ALERT SERVICE BULLETIN

Fuel pump assembly for ROTAX® Aircraft Engine Type 912 i (Series)

ATA System: 73-10-00 Fuel system

MANDATORY

Fig. 1

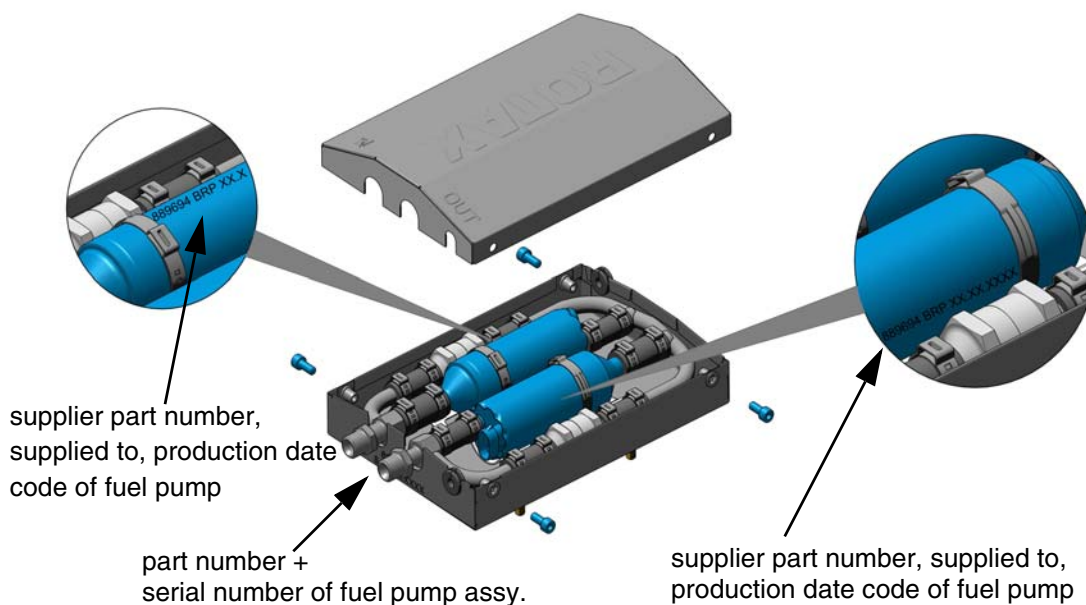
See Fig. 1 for information on how to find the part no. and S/N on the fuel pump assy.
